MEMORANDUM

Site Plan

PROJECT NAME: Ashton Knolls

8-02025

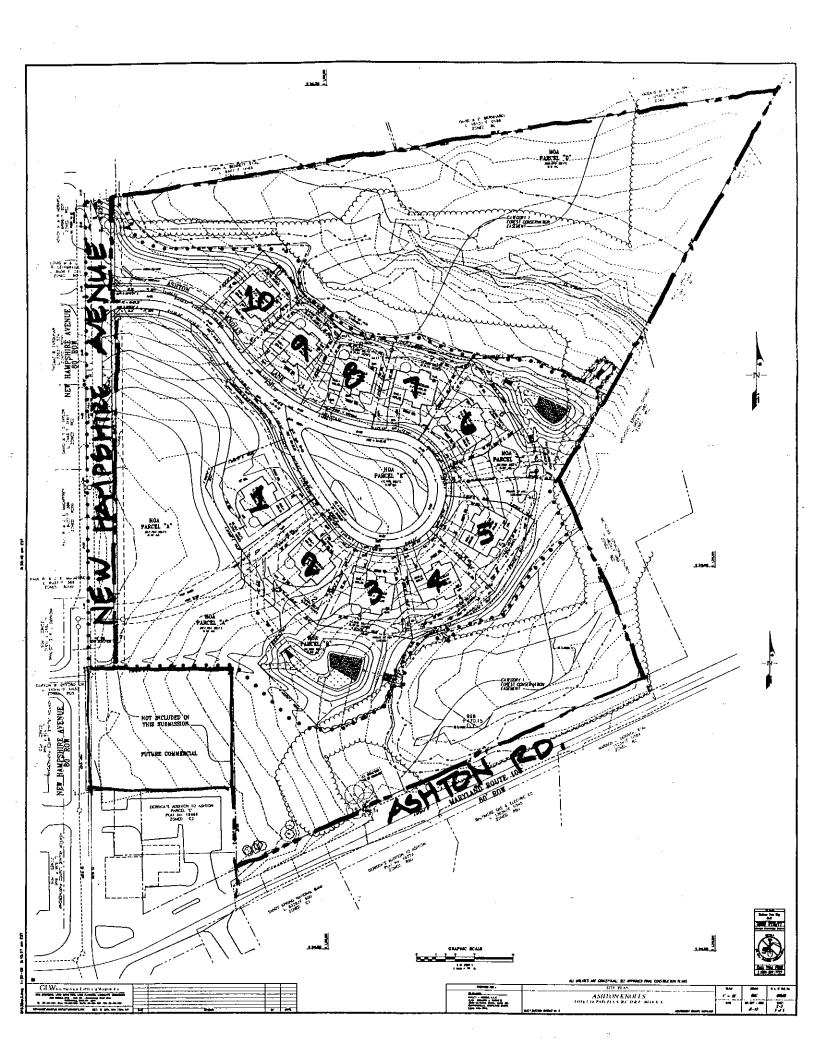
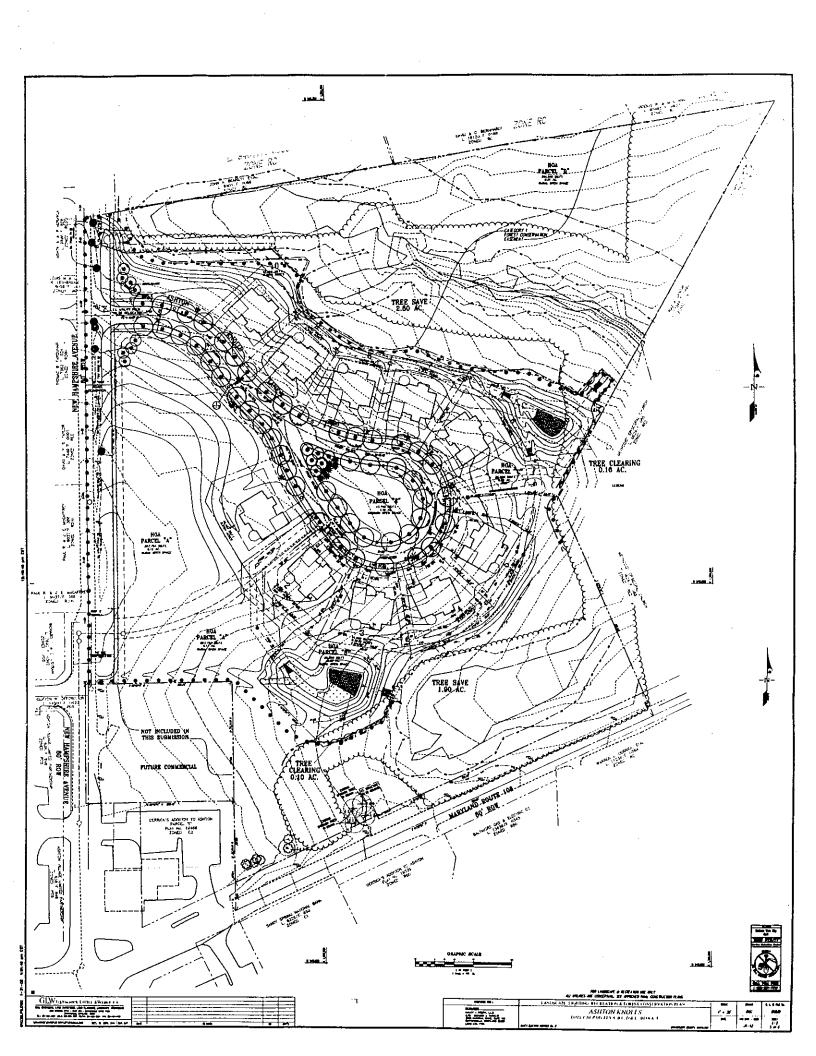
- a. <u>Lot 10</u> Slightly rotate house on Lot 10 so that front of unit faces New Hampshire Avenue;
- b. Lot 1 Shift the house on the lot, increasing the view of the side elevation from New Hampshire Avenue; provide architectural treatment (such as partial porch or stone terrace with landscaping) for façade, to face New Hampshire Avenue and achieve attractive effect compatible with Village Center area; provide a solid fence of natural stone, 6 feet in height, at the rear lot line to screen the back yard from view; provide landscape screening for the storm water vehicular passage between Lots 1 and 2;

- c. <u>Screening</u> Provide sight-tight solid fence of natural stone, 6 feet in height, for the rear lot lines of Lots 1, 2, and 3.
- d. Open Space Show a Category I Conservation Easement applied to:

- i. all Rural Open Space outside of the storm water management parcel(s);
 - ii. stream valley buffer;
 - iii. forest conservation areas:
- d. <u>WSSC Easement</u> Route the sewer and water connection easement through the subdivision street to New Hampshire to protect and preserve the open space conservation easement.
